SBN-363  
T.F. B7.1.2

Subject: Response to RAI 240.40 and 240.41(b); (Hydrologic and  
Geotechnical Engineering Branch)

PUBLIC SERVICE COMPANY OF NEW HAMPSHIRE  
SEABROOK STATION - UNITS 1 & 2  
FINAL SAFETY ANALYSIS REPORT

FLOW PATHWAYS FOR WAVE  
OVERTOPPING WATERS

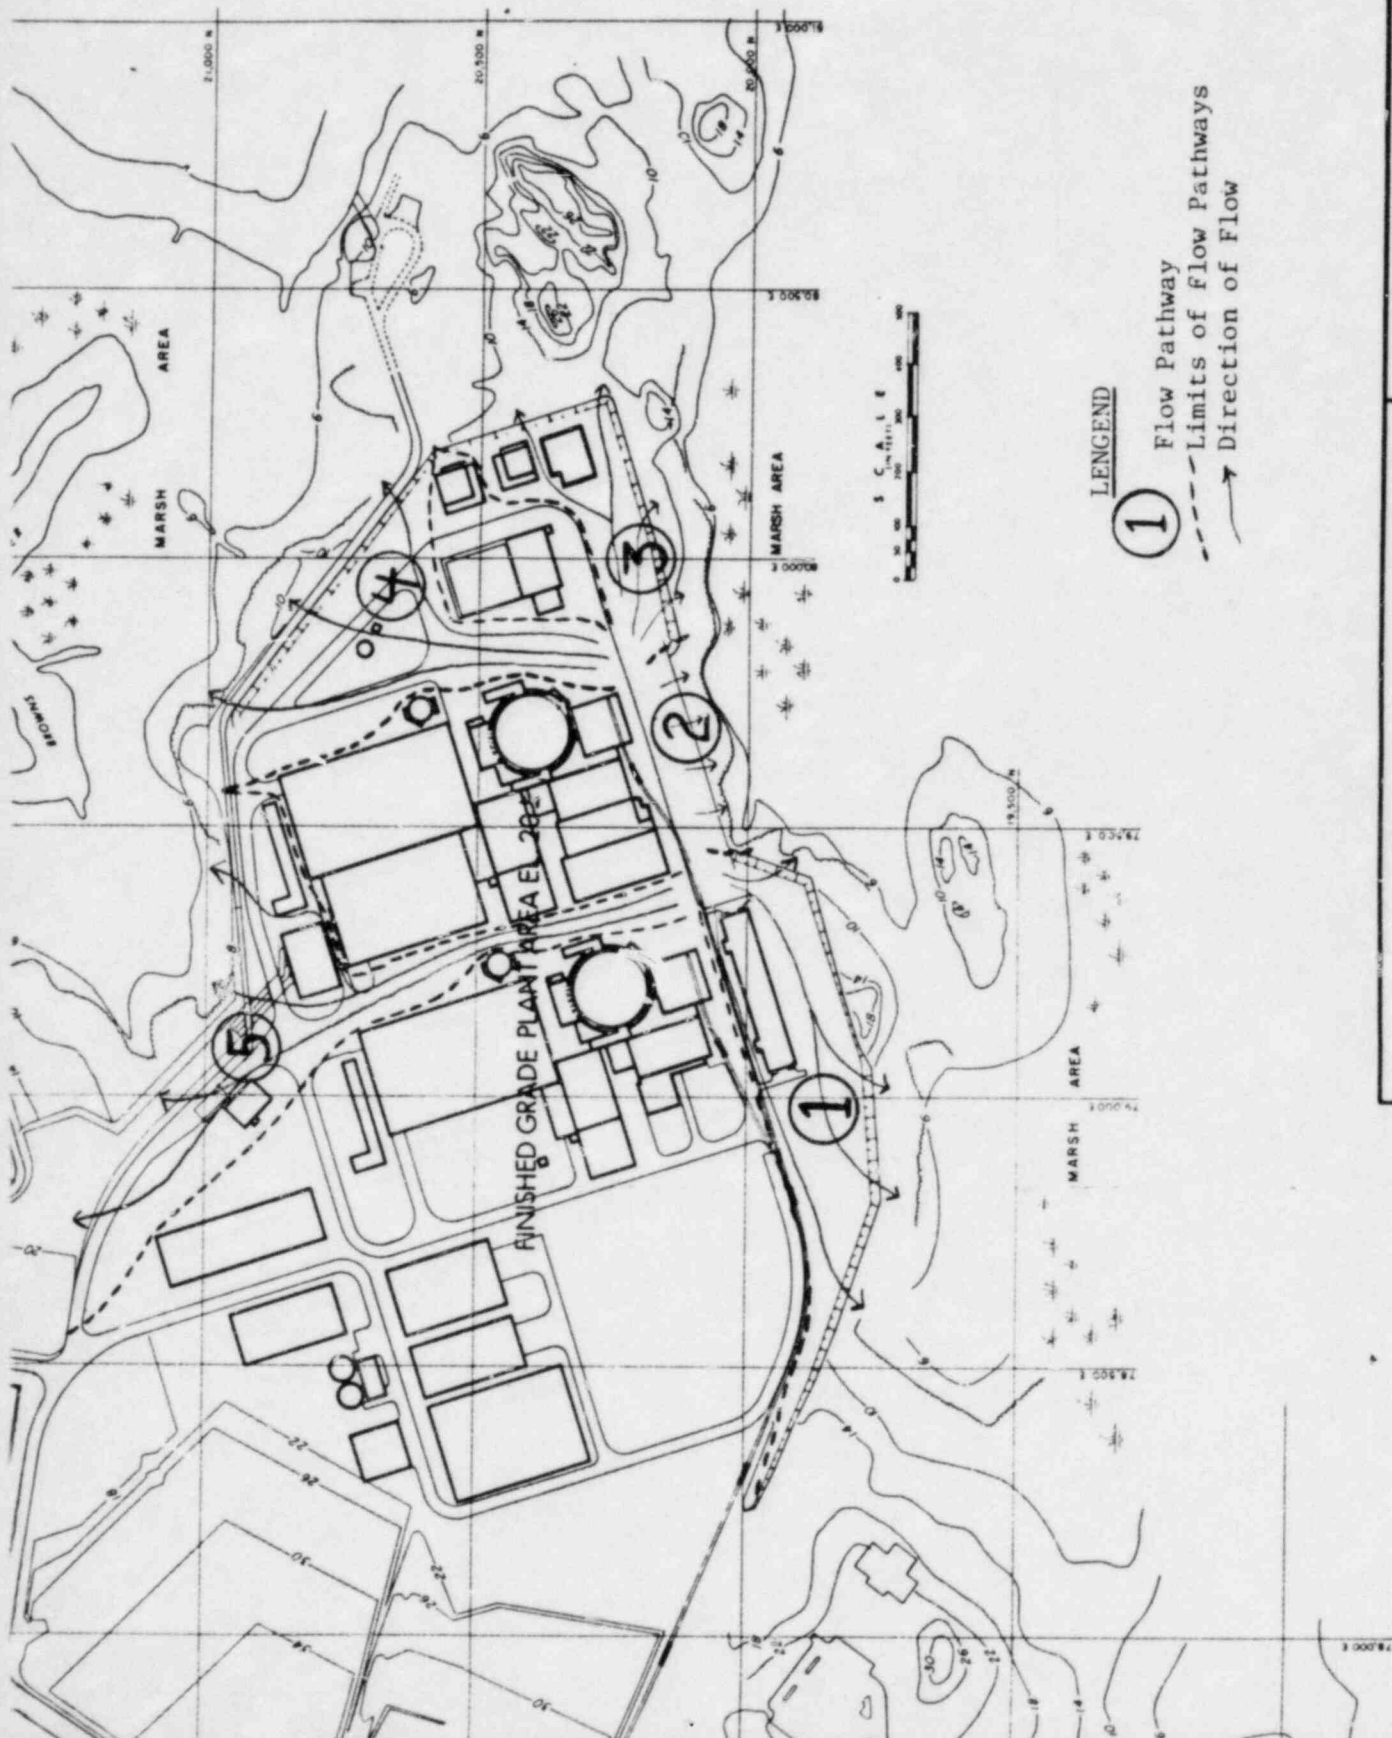
It is not apparent from our review of the ponding level on plant grade that concurrent intense precipitation was included in your wave overtopping runoff/ponding analysis. Therefore, provide a detailed analysis on the routing of the combined precipitation runoff from Probable Maximum Precipitation and wave overtopping runoff from the PMF/PMH event.

- a) If credit is taken for flow through the storm drainage system, provide justification that the storm drainage system cannot become blocked during this event.
- b) Identify the maximum water surface levels by location and elevation from the vertical seawall to the overflow weir (seawall).
- c) Identify plant access openings and sill elevations that may be affected by the runoff on plant grade.

Figure 240.41-1 shows the five major potential flow pathways for wave overtopping waters to exit the site. Flow pathways 1, 2 and 3 are assumed bounded to the north by the site perimeter roadway. Flow pathways 4 and 5 are bounded at both their upstream and downstream limits by the site perimeter roadway system with a crown elevation of 20.5 feet MSL.

An analysis was performed to estimate maximum water levels throughout the site, and the relative percentages of flow conveyed by the five previously identified flow pathways. Wave overtopping water was allowed to spread laterally into flow pathways 1 and 3 from 2 and north through 4 and 5 if the necessary hydraulic head was developed. Water was also allowed to return off-site over the vertical seawall, Pathway 2, during times when the seawall was not being overtopped.

The discharge capacity of each flow path was determined by iterating between inflow and outflow until they balanced within acceptable limits. Inflow to flow pathways was calculated using the Manning equation. Outflow was calculated using weir discharge at the overflow points. The slope used in the Manning equation being the ratio of the difference in head between inflow and outflow points to the average path length. To make these calculations, it was assumed that the area between the seawall and the roadway had a uniform head. This is a conservative approach in that no credit is taken for enhanced lateral flow away from the seawall area due to the hydraulic gradients which surely exist during overtopping.

Table 240.41-1 shows the discharge capacity of each flow path for various heads behind the seawall. As can be seen, a water level of about 21.0 feet MSL behind the seawall provides sufficient hydraulic gradient to produce flows which are approximately equivalent to the wave overtopping rate, taking no credit for site drainage. The water elevation within the roadway calculated by this method varies from about 21.0 feet MSL on the south of the site to 20.6 feet MSL on the north of the site, again taking no credit for site drainage. In actuality, there are over 50 catch basins within the roadway area with a drainage capacity well in excess of the combined flow rate of flow Pathways 4 and 5. It is extremely doubtful that all of these catch basins would be blocked and therefore it is concluded that the water level within the perimeter roadway is less than 21.0 feet MSL.

It is concluded that the maximum sustainable site ponding level at Seabrook Station for the combined PMF/PMH event is less than 21.0 feet MSL.
